Minutes – Executive Policy Committee – April 21, 2021

Item No. 7 Rezoning – 1350 Henderson Highway
(North Kildonan Ward)
File DAZ 212/2020 [c/r DAV 228606/2020D]

Title: DAZ 212/2020 – 1350 Henderson Highway

RE: PROPOSED REZONING OF LAND LOCATED AT 1350 HENDERSON HIGHWAY

1 / AS-101 SITE PLANTING PLAN
1" = 15'-0"

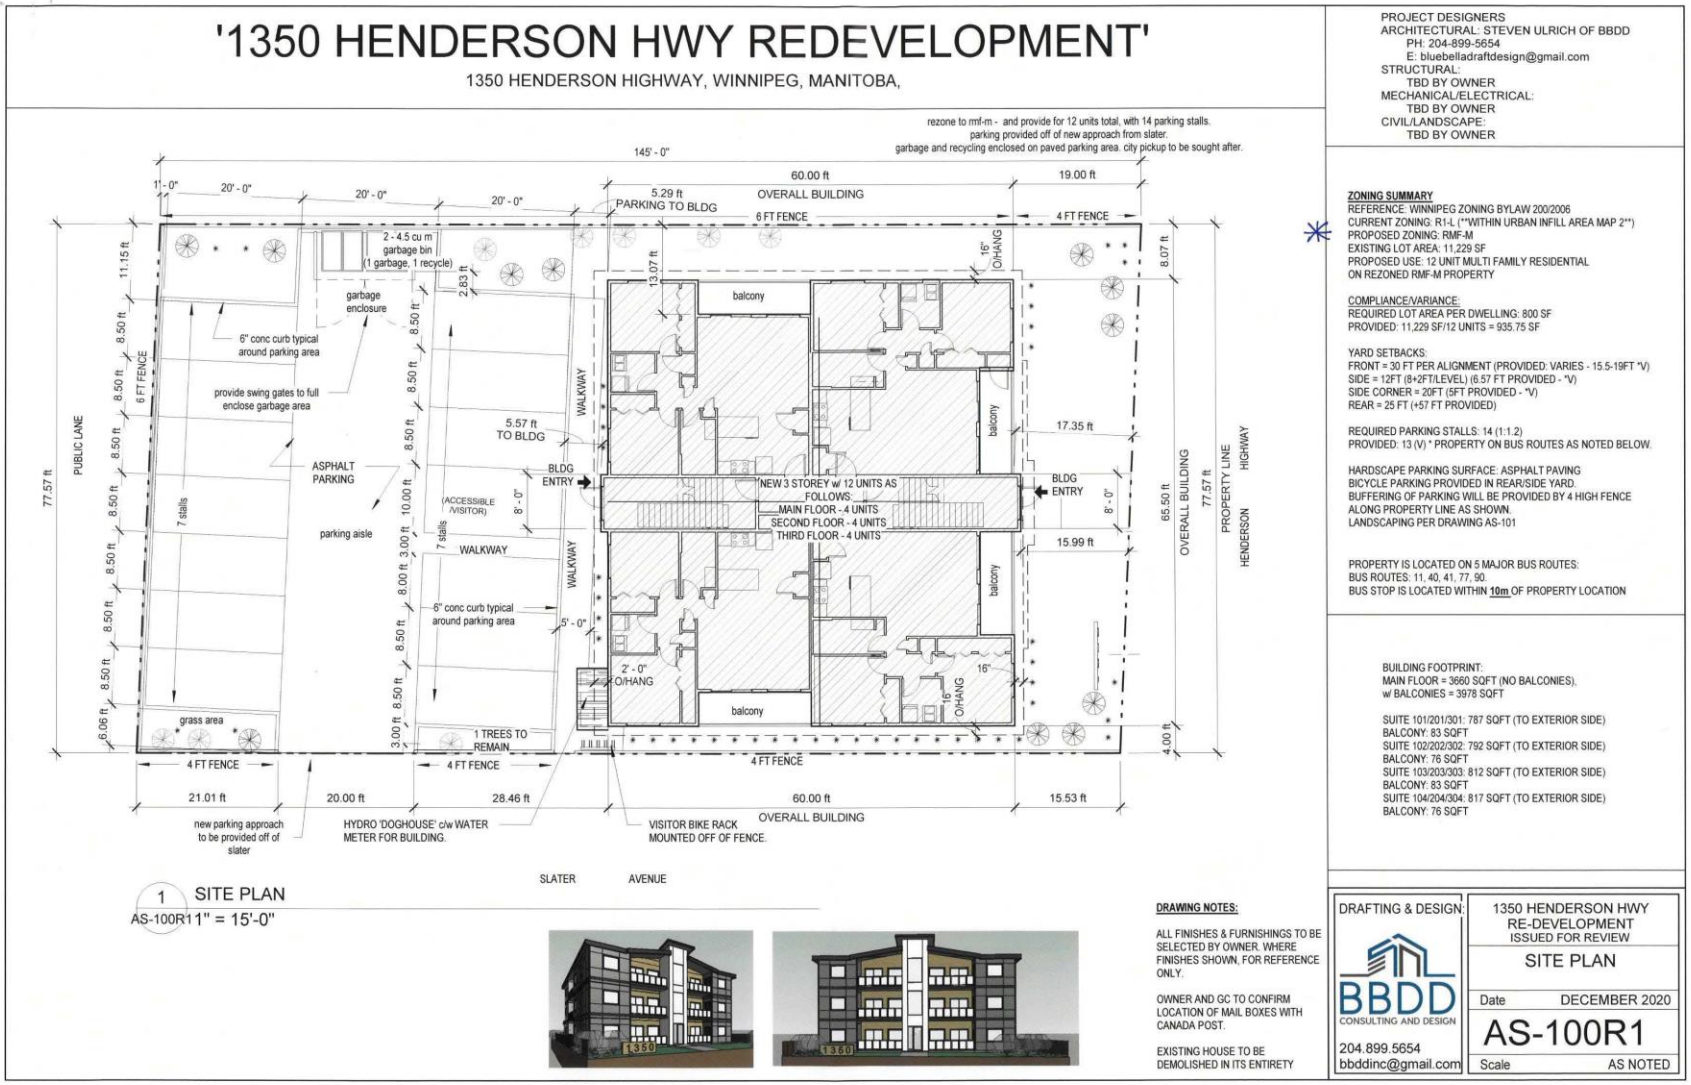
b. The proposed private approach to Slater Avenue is non-conforming under the Private Access By-law due to the proposed fence along the north side of Slater Avenue. The fence will need to be lower near the approach and/or stopped prior to the approach to increase sight lines;

c. No approaches will be permitted to Henderson Highway;

d. The existing private approach on the west side of Henderson Highway will need to be removed and the sidewalk, curb and boulevard works will need to be restored; and,

e. The site should be designed such that refuse vehicles are not backing out onto Slater Avenue; and,

The Public Works Department can work with the Developer through the private approach application.
